IN THE MATTER OF ROCKY MOUNTAIN POWER'S APPLICATION REQUESTING AUTHORIZATION TO UPDATE THE WIND AND SOLAR INTEGRATION RATE FOR SMALL POWER GENERATION QUALIFYING FACILITIES

CASE NO. PAC-E-23-24

COMMENTS OF THE COMMISSION STAFF

Attachment 1

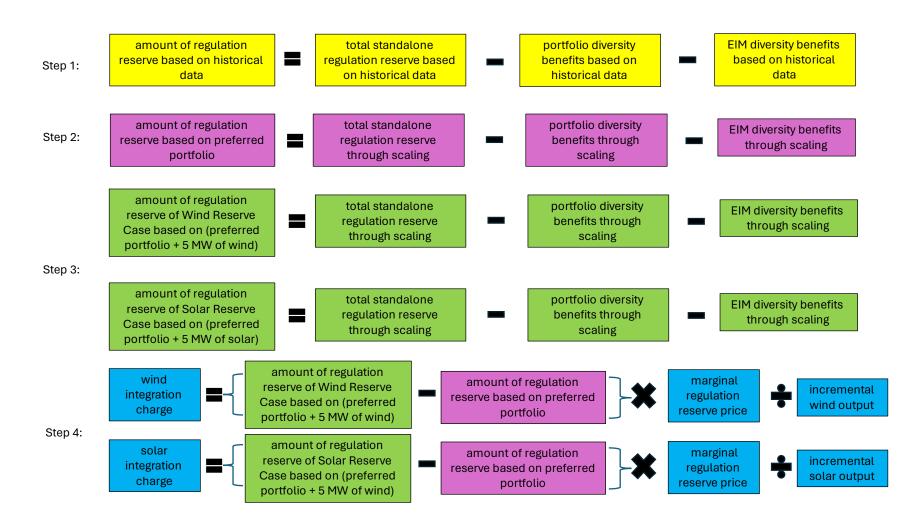
Staff believes the overall methodology used to determine integration cost in the proposed FRS is reasonable; however, Staff questions whether the capital and fixed O&M cost of reserves should be included. The calculation of wind and solar integration charges is based on the amount of regulation reserve necessary to accommodate changes in load and generation to maintain Area Control Error within mandatory parameters established by the BAL-001-2 standard. The Company's overall methodology includes four steps described below and is illustrated in Attachment 1 of these comments.

- The Company determined the amount of regulation reserves required for each class of variation (wind, solar, load, and non-variable energy resources¹) on a standalone basis for each hour during the historical period of 2018 and 2019. Because the variation of the different classes can cancel each other and because of the Company's participation in the Energy Imbalance Market ("EIM"), the total amount of reserves required for each class on a standalone basis was adjusted for the diversity benefits from the Company's resources and from the EIM.

- 2. The Company then developed a 20-year future baseline of regulation reserves based on the 2023 IRP preferred portfolio by scaling from the historical data in step 1.

- 3. After determining a future portfolio baseline, the Company constructed two separate cases: a Wind Reserve Case and a Solar Reserve Case by adding five Megawatts ("MW") of incremental wind to the future baseline and by adding five MW of incremental solar to the future baseline.

- 4. By calculating the difference in regulation reserve cost for each of the two cases relative to the future baseline established in step 2, the Company was able to calculate the

Although this method provides a reasonable method for determining the incremental energy cost to integrate wind and solar through the Company's production cost models, it does not capture any capital and fixed O&M costs of regulation reserves. *See* Response to Production Request No. 38.

The Company plans resources to meet its forecasted load plus a planning reserve margin ("PRM") in its integrated resource plans. The PRM includes an amount of regulation reserve resource capacity used to balance the different classes of variability considered in the integration charge. Thus, Staff believes an allocation of that capacity cost to integrate wind and solar should be included. When asked why the proposed integration charges did not include any cost of capacity, Staff believes the Company's response did not provide sufficient evidence why capacity cost was not included. *See* Response to Production Request No. 39. Staff recommends that the Company explain why capital and fixed O&M cost of regulation reserves should not be included in wind and solar integration costs supported by quantifiable evidence in the next FRS.
